## Invitation to Bid ITB23/02641 Amendment no. 2

**Subject: EU4MD / Purchase of Technical equipment for the provision of public services in Cahul and Ungheni (14 LOTS)**

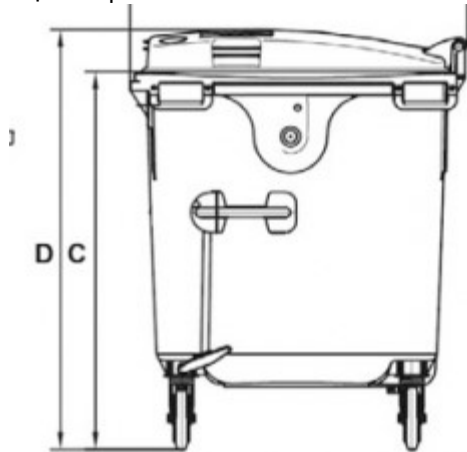
Q2. We have two resistance handles on two sides of body (total four resistance handles). No front grip.

A2. It is acceptable.
